**PLANNED UNIT DEVELOPMENT  
STAFF REPORT****Date: June 7, 2012****DEVELOPMENT NAME**

Pinebrook Investment

**CONTEMPLATED USE**Planned Unit Development Approval to amend a  
previously approved Planned Unit Development to allow  
the reconfiguration of accessways and traffic patterns.**TIME SCHEDULE  
FOR DEVELOPMENT**

# SITE PLAN

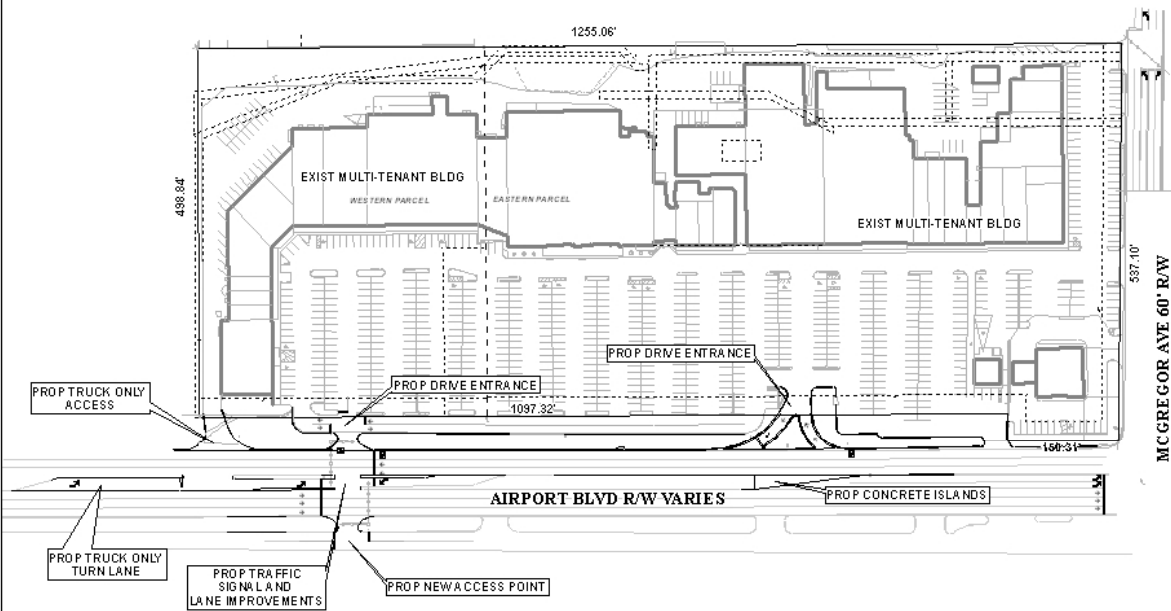
A traffic impact study is required to illustrate that the traffic signal warrants outlined in the 2009 Manual on Uniform Traffic Control Devices could be satisfied. A draft report was provided to Traffic Engineering that was incomplete. The

development information for the site and the proposed improvements differ between the submitted PUD site plan and the draft report. Improvements in the draft study included removal of the traffic signal accessing the site from McGregor Avenue and striping changes on McGregor Avenue at the Airport Boulevard intersection. Additionally, physical improvements should be made to restrict turning movements at the “right-in, right-out” driveway on McGregor Avenue to “provide a more efficient, effective and compatible traffic flow for existing traffic” for both adjacent roadways. The “truck access only” driveway and median opening is not acceptable and will not be permitted. The rear circulation of the building is designed to be one-way, based on the angle of the parking in the northeast and southwest corners, and the reduced aisle width in the northeast corner and north-central area of the site. The alignment of a proposed driveway with a traffic signal on Airport Boulevard should be further coordinated with Traffic Engineering, especially as it relates to access of the service road south of Airport Boulevard. This may require closure of access points in the vicinity of a proposed traffic signal. Any resubmitted site plans should include driveway curb-cuts across from the property, both on the mainlines and service roads, to better illustrate the access around the site and what could be impacted.

The site fronts Airport Boulevard and McGregor Avenue South, both planned major streets. Each right-of-way should be a minimum of 100-feet, as recommended by the Major Street Plan component of the Comprehensive Plan: the site plan does not include right-of-way width information, however, it appears that the right-of-way for McGregor Avenue South is not adequate. The 2009 approved PUD for the new Regions Bank included the following requirement, which has not apparently been met:

Finally, it appears that the submitted site plan does not reflect the current tenant mix of the shopping center, in that tenants are shown which are no longer in business. Furthermore, Urban Forestry has requested compliance with the frontage tree requirements of the Zoning Ordinance. The site plan should be revised to accurately reflect the tenant mix at time of application, and to show existing trees (size, species) on site.

- 3) Revision of the PUD site plan to reflect Traffic Engineering comments (*A traffic impact study is required to illustrate that the traffic signal warrants outlined in the 2009 Manual on Uniform Traffic Control Devices could be satisfied. A draft report was provided to Traffic Engineering that was incomplete. The development information for the site and the proposed improvements differ between the submitted PUD site plan and the draft report. Improvements in the draft study included removal of the traffic signal accessing the site from McGregor Avenue and striping changes on McGregor Avenue at the Airport Boulevard intersection. Additionally, physical improvements should be made to restrict turning movements at the "right-in, right-out" driveway on McGregor Avenue to "provide a more efficient, effective and compatible traffic flow for existing traffic" for both adjacent roadways. The "truck access only" driveway and median opening is not acceptable and will not be permitted. The rear circulation of the building is designed to be one-way, based on the angle of the parking in the northeast and southwest corners, and the reduced aisle width in the northeast corner and north-central area of the site. The alignment of a proposed driveway with a traffic signal on Airport Boulevard should be further coordinated with Traffic Engineering, especially as it relates to access of the service road south of Airport Boulevard. This may require closure of access points in the vicinity of a proposed traffic signal. Any resubmitted site plans should include driveway curb-cuts across from the property, both on the mainlines and service roads, to better illustrate the access around the site and what could be impacted.*);

- 4) Revision of the PUD site plan to reflect Urban Forestry comments (*Property to be developed in compliance with state and local laws that pertain to tree preservation and protection on both city and private properties (State Act 61-929 and City Code Chapters 57 and 64). Full compliance with frontage tree requirements of the Zoning Ordinance to be coordinated with Urban Forestry.*);

- 5) Revision of the PUD site plan to accurately reflect the tenant mix at the time of application;
- 6) Revision of the PUD site plan to show all existing trees by species and size; and

- 7) Revision of the PUD site plan to accurately label right-of-way widths for Airport Boulevard and McGregor Avenue South, with minimum and maximum widths.
